**TECHNICAL SPECIFICATIONS**  
**FOR THE**  
**UNIVERSITY OF VIRGINIA**  
**REACTOR**

FACILITY LICENSE No. R-66  
DOCKET No. 50-62

*As Revised to Facilitate*  
*Permanent Reactor Shutdown, Decontamination and Decommissioning*

September 25, 1998

Figure 6.1 Organizational Structure of U.VA. Relating to Reactor Facility

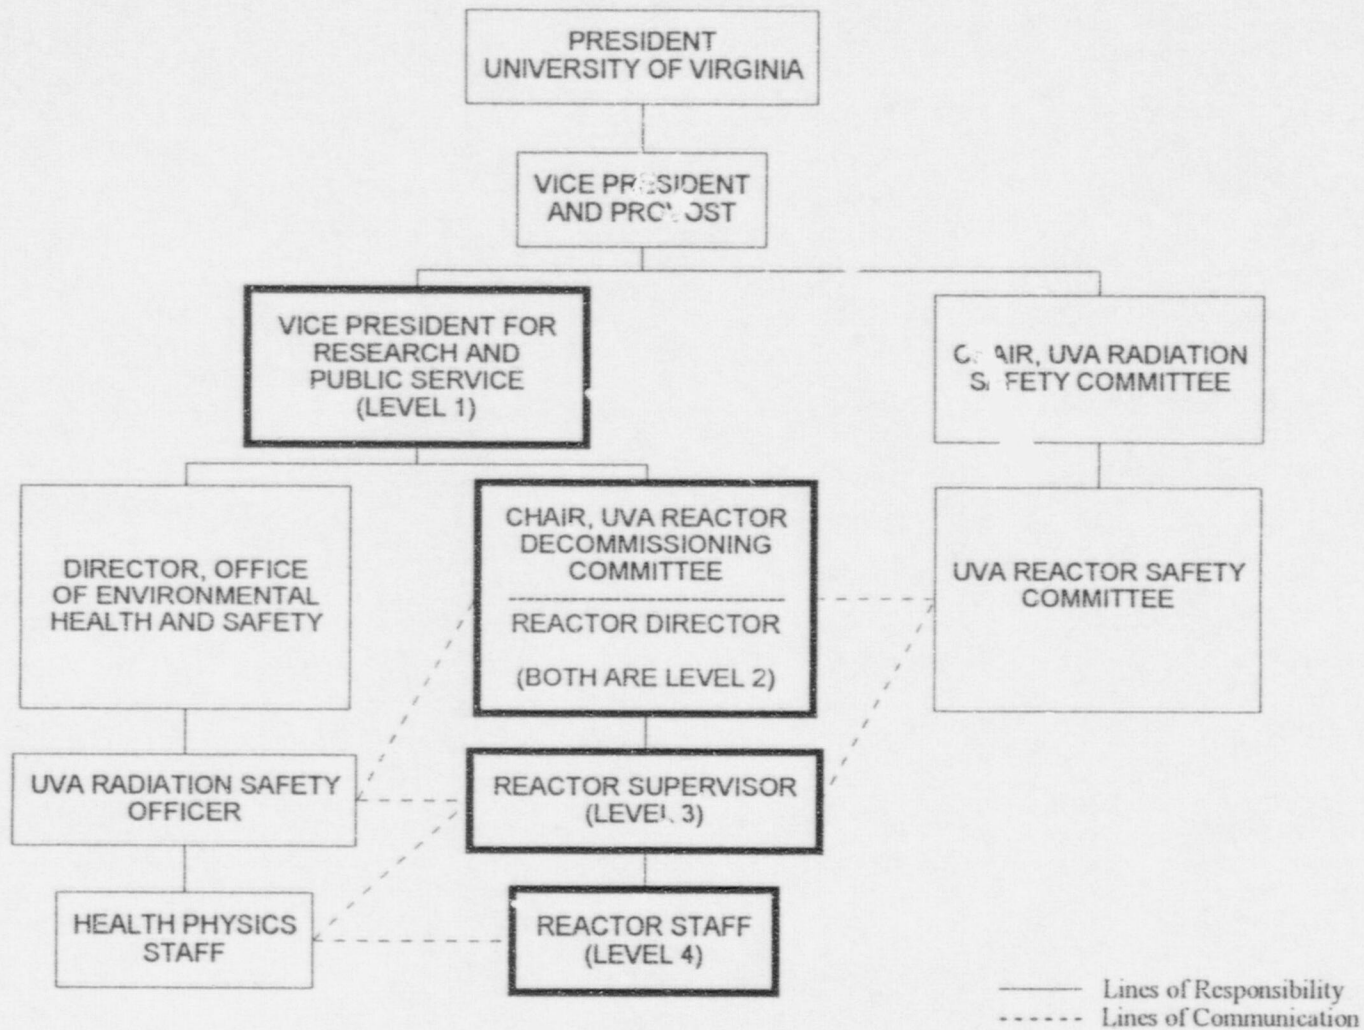
The Reactor Facility shall be an integral part of the University of Virginia. The organizational structure of U.Va. relating to the Reactor Facility is shown in Figure 6.1. *The Vice President for Research and Public Service (Level 1) shall have overall responsibility for management of the Facility.*

*A licensed Senior Reactor Operator shall supervise any movement of reactor fuel. One or more health physicists, organizationally independent of the Reactor Staff as shown in Figure 6.1, shall be responsible for radiological safety at the Reactor Facility.*
